21-006ARB-INF – 181 S. HIGH STREET

Summary

Informal review and feedback for demolition of an existing structure and construction of a new single-family home on a 0.47-acre site.

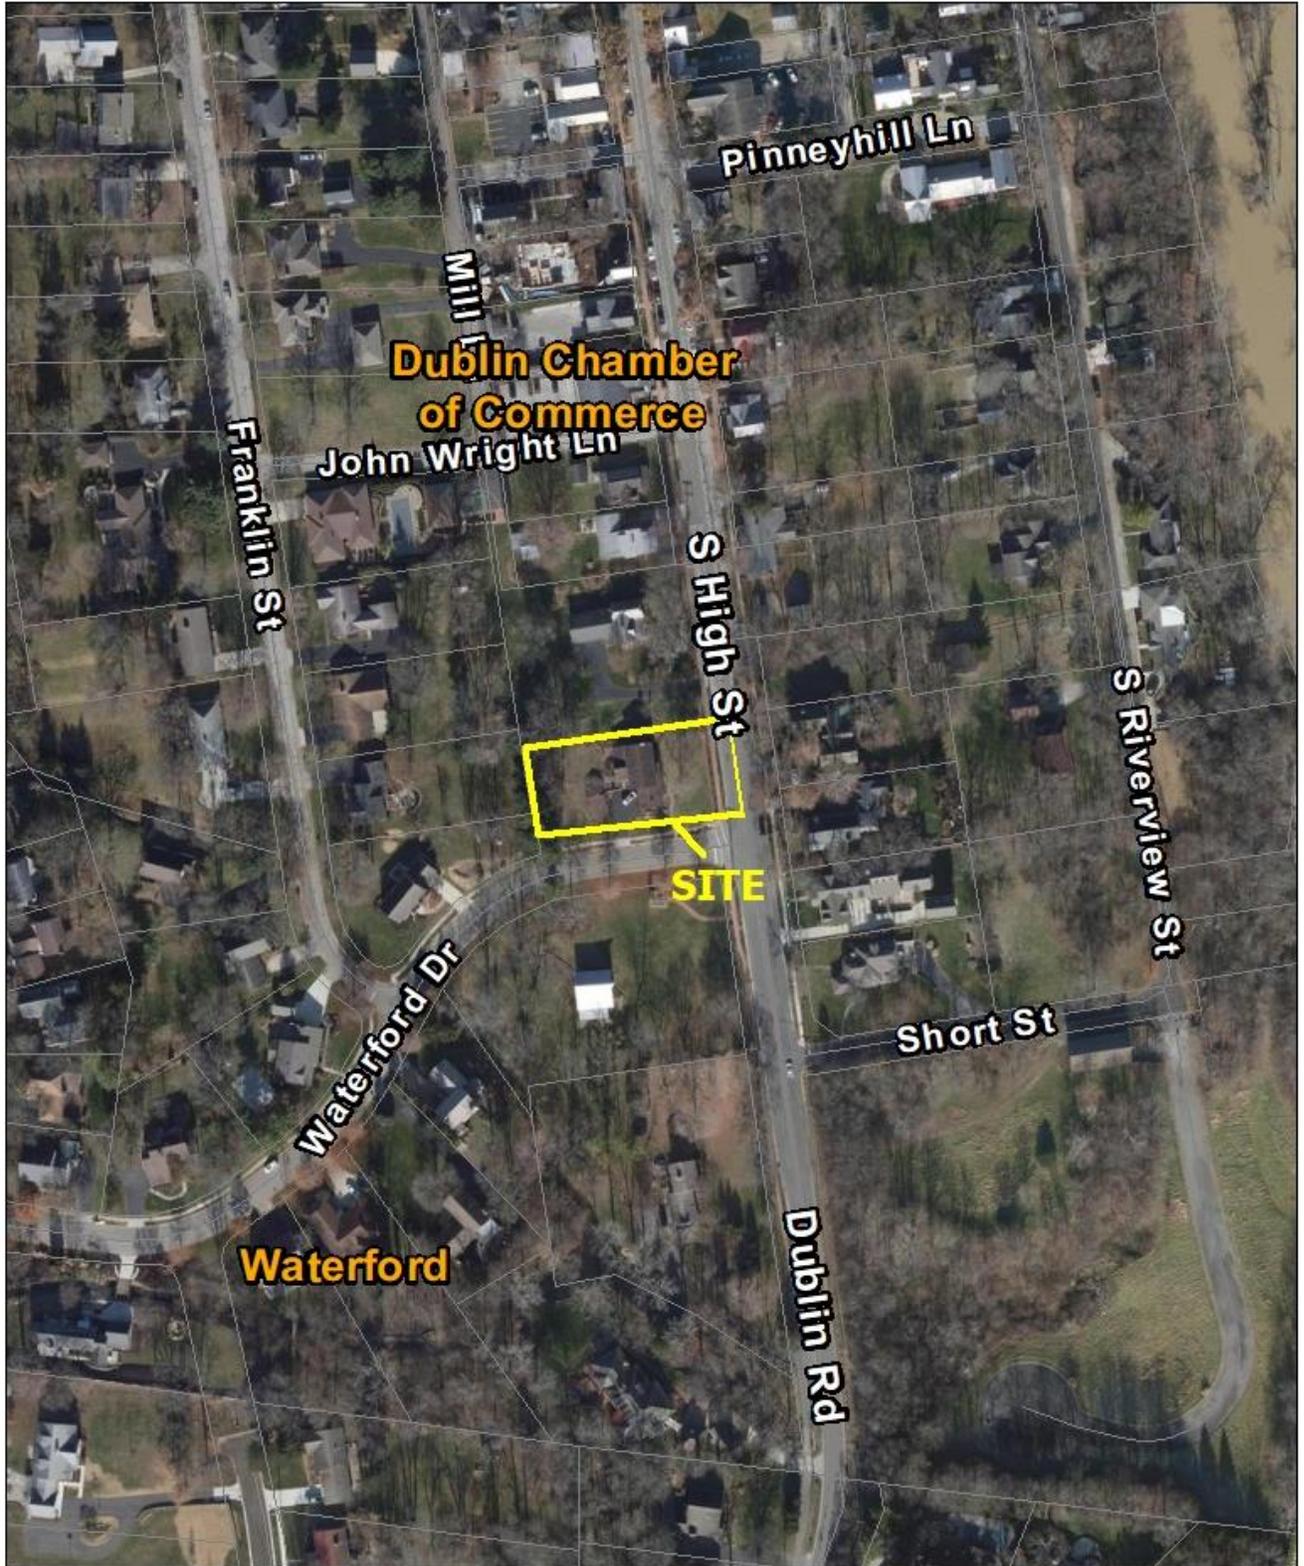
1. Context Map

<p>City of Dublin</p>	<p>21-006INF Informal Review 181 South High Street</p>	<p>0 75 150 Feet</p>	
---	--	--------------------------	---
